## ON-SITE SEWAGE DISPOSAL SYSTEM HOWARD COUNTY HEALTH DEPARTMENT BUREAU OF ENVIRONMENTAL HEALTH

**04-334973**

SUBDIVISION: Stanley B. Miller Property LOT NUMBER: 23

ADDRESS: 16483 Frederick Road PROPERTY OWNER: Joan Alascio

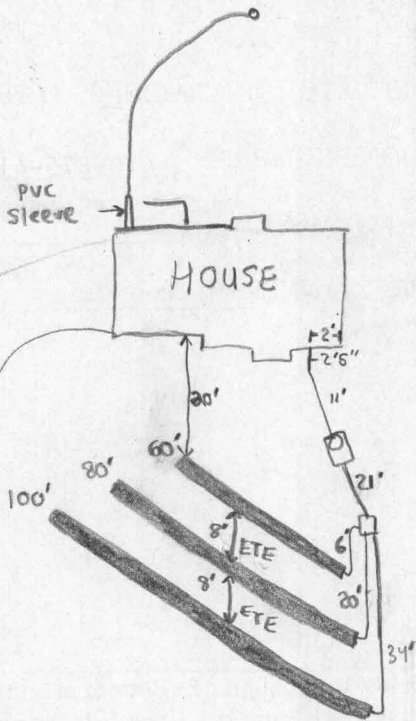
8/20/01 - Still Needs Stakeout of trenches before go ahead on construction. JPP

PRE-CONSTRUCTION INSPECTION: 8/21/01 @ 11:30 A Met Builder @ Site - No Sighting of Trenches evident, piles of fill dirt in

lower, Eastern portion of SDA. Sept Contractor needed as Builder Had No Idea. Owners of SDA were stoked. App

INSPECTION COMMENTS: 8/21/01 - OK TO COVER ALL WORK - SRK
